UNITED STATES
NUCLEAR REGULATORY COMMISSION
WASHINGTON, D. C. 20555

Docket No. 50-341

FACILITY: Fermi 2

SUBJECT: SUMMARY OF MAY 27, 1981 OL REVIEW MEETING REGARDING THE FERMI 2
FIRE PROTECTION REVIEW

ENCLOSURE 2

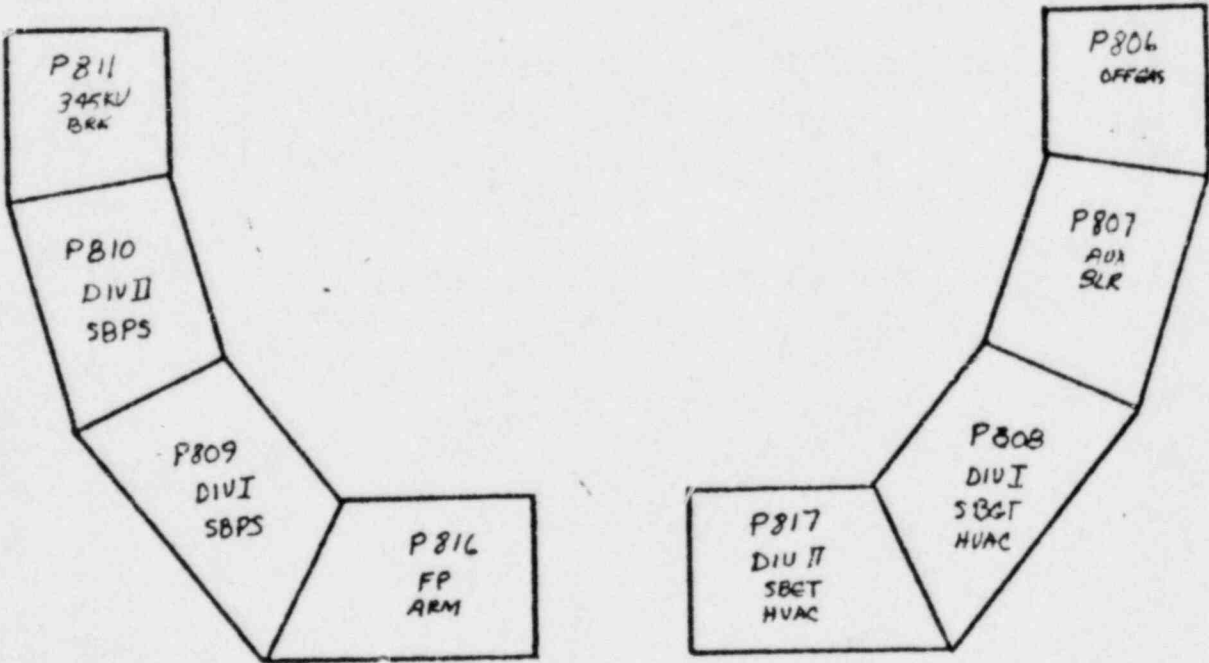
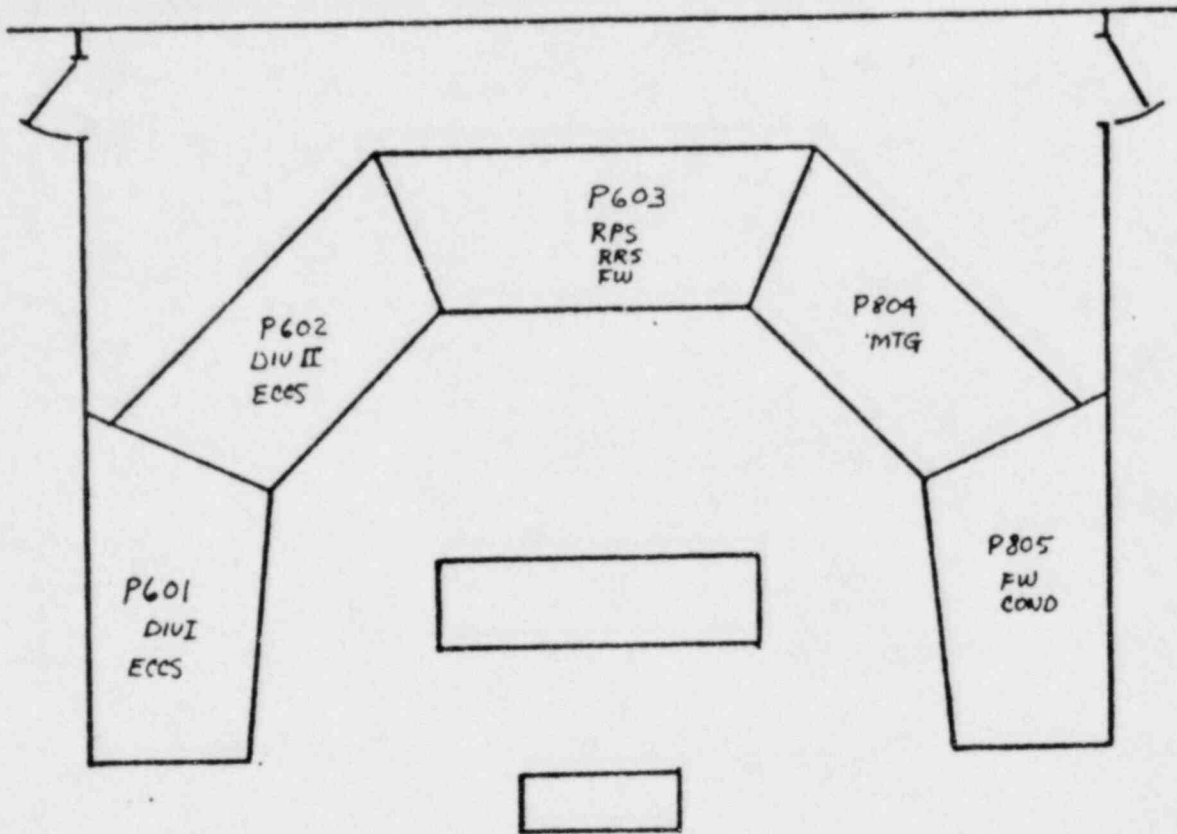
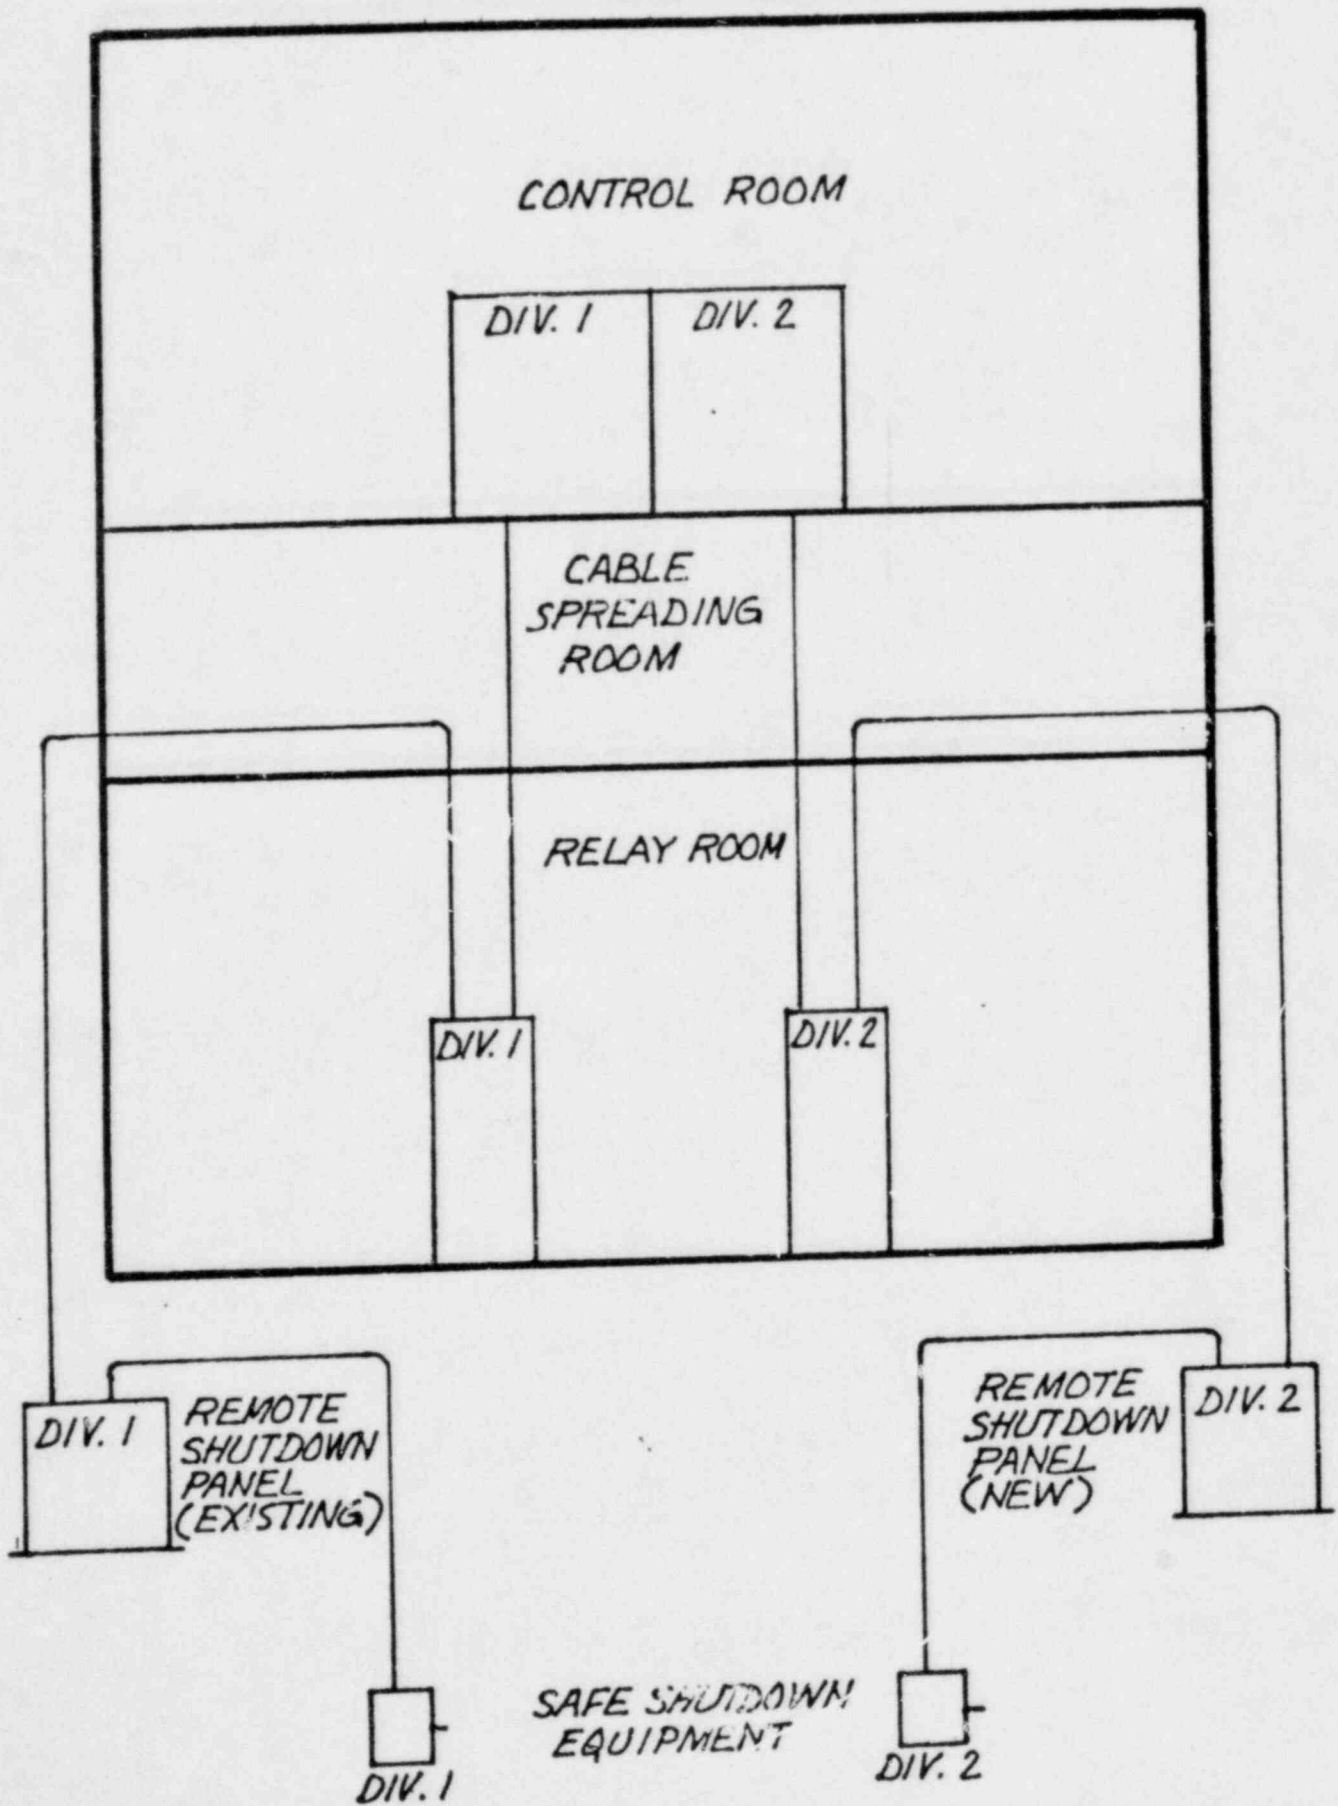
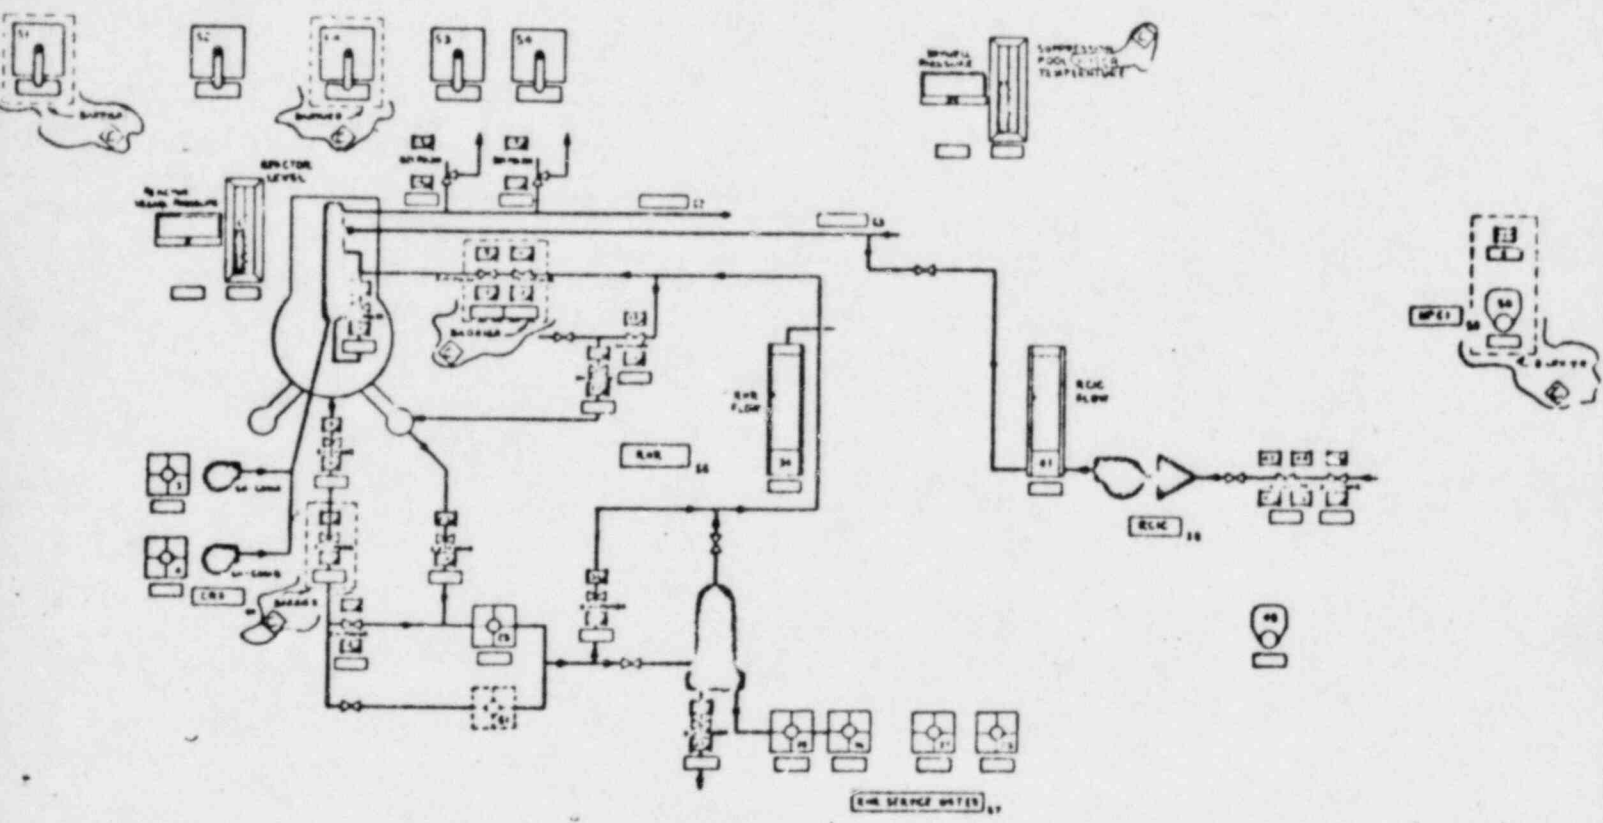
Enclosure 2 is a copy of slides showing existing and proposed alternate shutdown capability for a fire in the control room. The proposed system would provide a means for hot shutdown from outside the control room, if only one control panel is destroyed by fire.

- (2) A fire in the control room external to the panels must be considered, e.g. due to a spill of a flammable fluid. Applicant stated it will run a test to demonstrate that its panels will protect the wiring and switches inside of the panel from such a fire. Staff will consider test plans and test results in its evaluation.
